DCN No. E020653-00-C

# Document Change Notice (DCN)

DOCUMENT No. (DOC-REV-GP.ID)	TITLE	NEW REV
D010285-A	Variable Delay Timing Board	A1

Fig 1: The PCB Board (D010285-A) change to D010285-A1

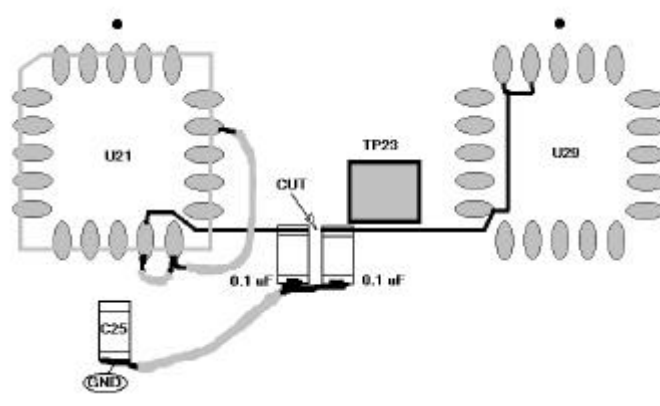
- (1). The Vbb pins of U21 and U29 are tied together.
- (2). The unused inputs of the MC10H115 (U21) are not tied to its Vbb as stated in the data sheet.
- (3). The Vbb pins of U21 and U29 are not bypassed as per the data sheets.

**REASON FOR CHANGE:** Didn't use the IC's U21 and U29 as per the Data sheets.

- (1). Cut the trace that connects U21 pin 12 and U29 pin 8
- (2). Connect U21 pins 12, 13 and 17 together.

(3). Solder a 0.1 uF SMT capacitor between U21-12, U29-8 and ground.

(See the Fig 1. for the PCB Board change)
